Londonderry Conservation Commission
Tuesday, May 26, 2009
Minutes
Page 1 of 5

7
8 PSNH D+F- Nick Golan of TFMoran was joined by Laura Games and Alison McLean of Public Service
9 of New Hampshire to review a Dredge and Fill application regarding the ongoing expansion of their
10 Scobie Pond substation. The existing yard will be expanded to accommodate a new transformer being
11 installed for anticipated needs. Using photographs (see attached), N. Golan identified that on the
12 northeast end of the existing yard, approximately 75 feet of wooded area will be cleared heading in a
13 northerly direction. An adequate buffer will remain between PSNH's lot and the abutting neighbor to the
14 northwest.

57
58 Aviation Park Drive D+F- Todd Connors of Sublime Engineering and Eric Skinner, owner of Trimmers
59 Landscaping, presented a D+F request involving wetland impacts on 3 Aviation Park Drive (14-29-10).
60 E. Skinner is proposing a 16,600 sf building on the site for both his business as well as several other
61 future tenants. Impacts to the wetland in the middle of the lot would total 9,600 sf due to a portion of the
62 building footprint and the loading area behind it (see attached p

Area of Scobie Pond Substation Expansion (Southwest End)

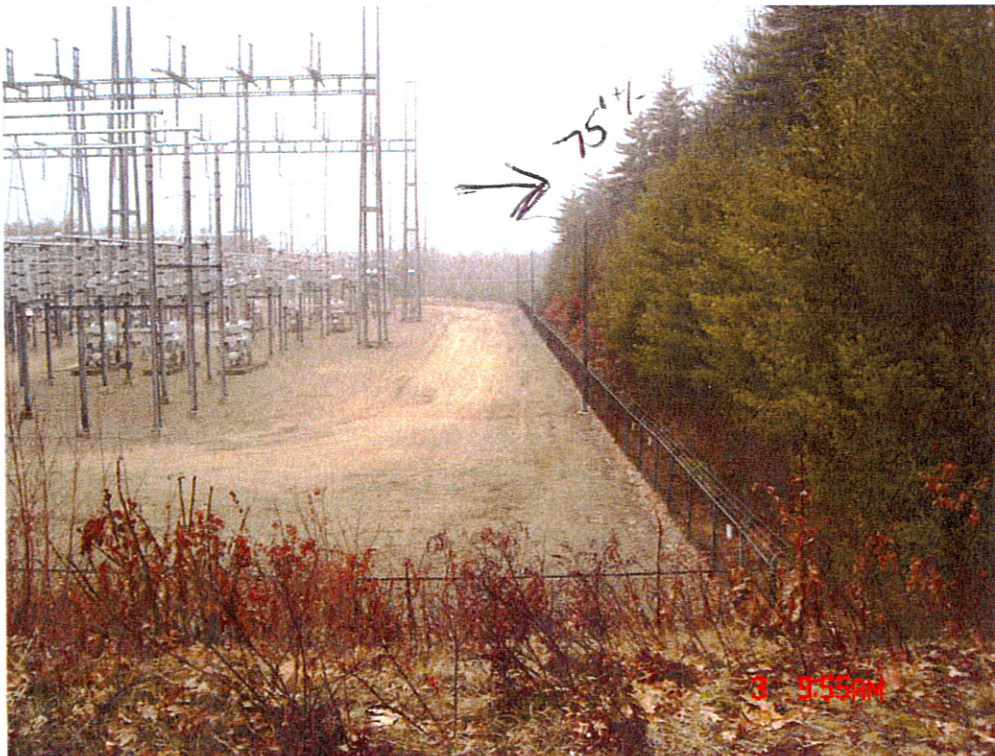
17
18 A second expansion will occur on the southwest end of the yard where discharge from an existing
19 storm water pipe has created a wetland. N. Golan described the resulting D+F request as the filling of
20 2,150 square feet of a wetland mostly created by PSNH, which he noted has a lower function than the rest
21 of the wetland. The intention of the design is to try and balance the cut fills needed for the site while
22 maintaining the necessary height of a nearly 200-foot long modular block retaining wall which nearly
23 splits the area of wet in half. He explained that the required 12 foot height of the wall is stabilized by
24 structural fabric called a geo-grid that cannot extend into the containment area of the new transformer and
25 therefore adds to the wetland infringement. Beyond the wall area, the remainder of the outside edge will
26 mostly be a 3:1 slope. An adequately sized area has been prepared for the construction zone so as not to

27 further impact the wetland while building the wall.

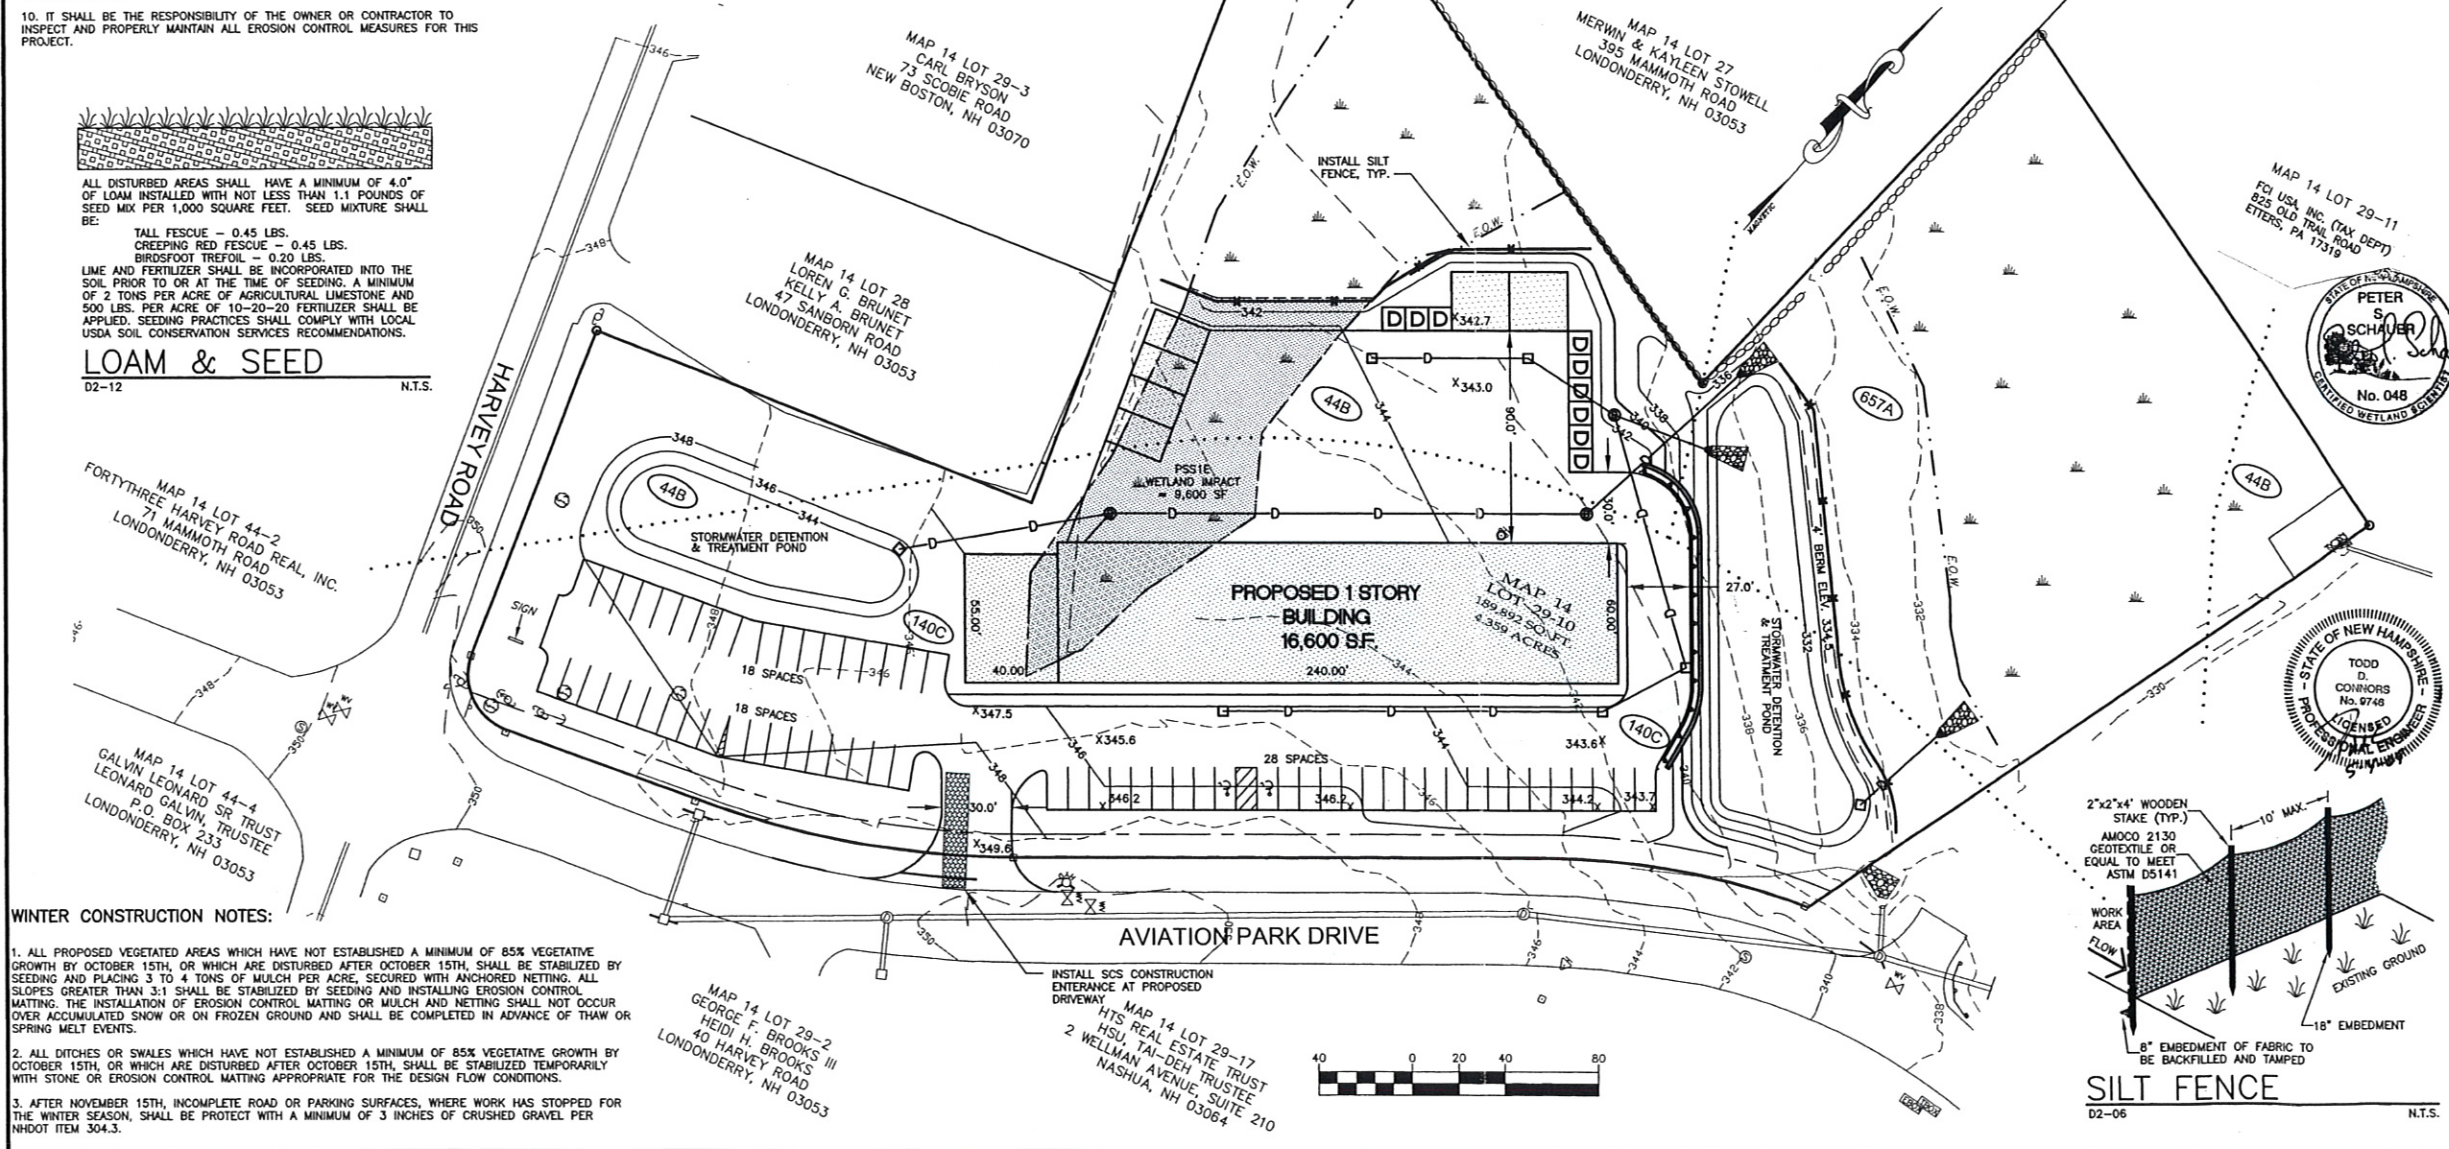
81 infiltrated underground. M. Considine asked if filling the wetland will force it onto the abutting
82 neighbor's property. Because of the created drainage and storage ability of runoff, T. Connors said that
83 should not be an issue.

95 A landscape plan is forthcoming to fulfill Town requirements and provide native species,
96 including drought and salt tolerant species. D. Lievens asked if the Birdsfoot Trefoil seed mix noted on
97 the plan is still the required by DES for erosion control since it is a non-native species. T. Connors said
98 he would check the most recent publication to ensure that it is still part of their best management
99 practices. She also inquired as to whether space has been allocated on the plan for trucks to maneuver
100 around the backside of the building. T. Connors said that area was included but that it still needs Fire
101 Department approval.

102 D. Lievens then asked why the plan identifies 12 more parking spaces than the Town requires.
103 Parking for this project, T. Connors explained, is related directly to the use of the building. Aside from
104 the parking needed for the separate tenants in the building, E. Skinner's landscaping business relies
105 heavily on outside workers who park their personal vehicles on site and then take company vehicles to job
106 sites. Extra spaces were therefore integrated into the plan, however T. Connors noted that like the
107 building itself, the thirty six spaces closest to the intersection would be constructed in phases once their
108 need is determined. M. Speltz asked if a variation of the plan had been considered where the building
109 would sit closer to the Harvey Rd/Aviation Park Dr., especially since constructing the parking in phases
110 might reveal less of a need in the end. T. Connors explained that trying to squeeze some of the parking

111 along with the building in that corner would eliminate the possibility of the loading area. He also noted
112 that the chosen location of curb cut off Aviation Park Drive would be difficult to rearrange as it just meets
113 the Town's sight distance requirements. M. Considine pointed out a discrepancy in the written description
114 of the plan that identified only 40 total parking spaces. T. Connors said he would double-check the
115 numbers but was fairly certain the total would be the 64 drawn on the diagram.

116 When asked if gravel could be used instead of pavement, T. Connors replied that concern over
117 aesthetic presentation of the site at the corner resulted in the choice of pavement. D. Lievens then asked if
118 the pavement used could be of a pervious material but T. Connors stated that it would not effectively
119 handle the amount of debris associated with a landscaping business. M. Speltz asked that T. Connors
120 check with the University of New Hampshire Storm Center regarding the amount of debris and the
121 potential for using pervious pavement.

126 M. Speltz noted that the wetland impacts were just 400 sf short of the 10,000 sf that would prompt
127 a mitigation requirement by the State. While acknowledging that the aforementioned wet ponds would
128 provide some compensation, he asked if further mitigation could still be considered to offset the impacts.
129 T. Connors responded by explaining that the ponds will be recreating wet areas equal to the amount to be
130 filled and will be more active in their treatment of runoff. This topic as well as permeable pavement and
131 other issues raised can be revisited with the forthcoming CUP application CUP and design review
132 process.

133 **K. Henault made a motion to draft a letter to the Wetlands Bureau in support of the D+F**
134 **application, acknowledging the plans for phased parking and with the recommendation of the use**
135 **of permeable pavement in that area of phased parking. M. Considine seconded. The motion was**
136 **approved, 7-0-0.**
